# Service Information

Category <b>C</b>	<b>Repair Guidance</b>	Ref. No. R046/05 <b>C</b>	Page 1 of 3
Coverage <input type="checkbox"/> Distributor only <input checked="" type="checkbox"/> Please inform your dealers		Date Issued November 24, 2005	
Please convey this information to your <input checked="" type="checkbox"/> Warranty Dept. <input checked="" type="checkbox"/> Parts Dept. <input checked="" type="checkbox"/> Training Dept. <input type="checkbox"/> Director <input checked="" type="checkbox"/> General Manager <input type="checkbox"/> Field Rep.		Date Revised May 28, 2010	
Applicable Models  RX-8 (FE / SE)	Applicable Countries or Specifications  US, EC and ADR Spec.

## Subject: Hesitation and Idle Vibration Due to Cracks on Engine Mount

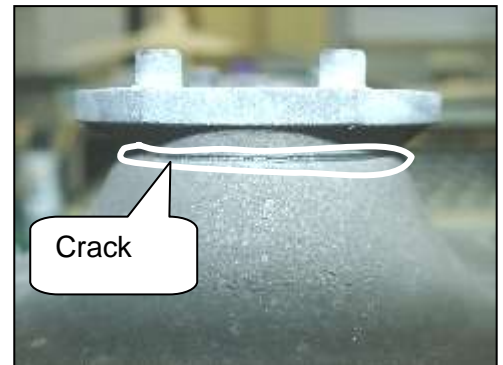
Some vehicles experience a crack appears on the RH side engine mount. As a result, the following symptoms may be observed.

Depending on a driving condition or engine condition, the RH side engine mount rubber may get deformed and wrinkled. As a result, the crack is caused starting from the wrinkles.

The material of engine mount rubber has been changed.

Repair Procedure

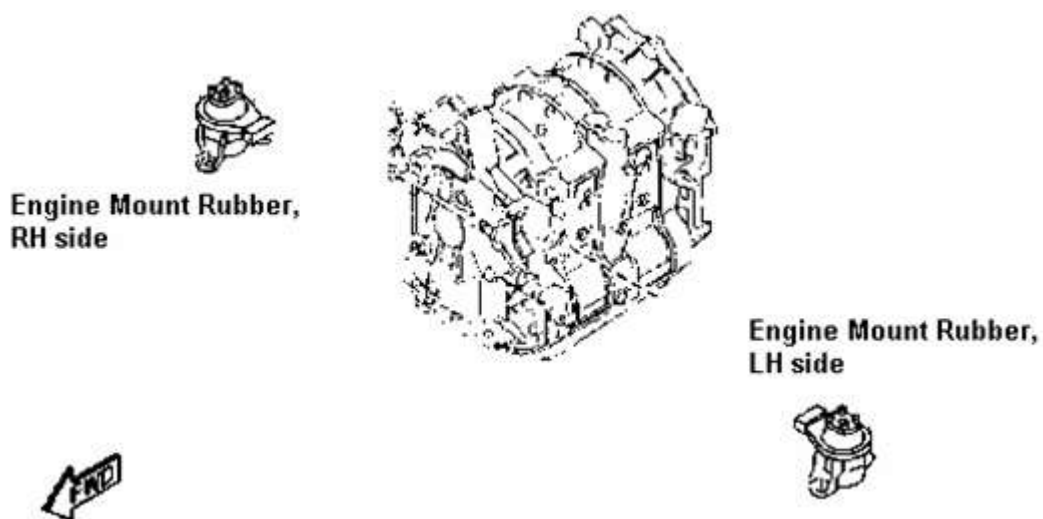
When you encounter a customer complaint on this concern, replace both right and left engine mount rubbers with modified ones.
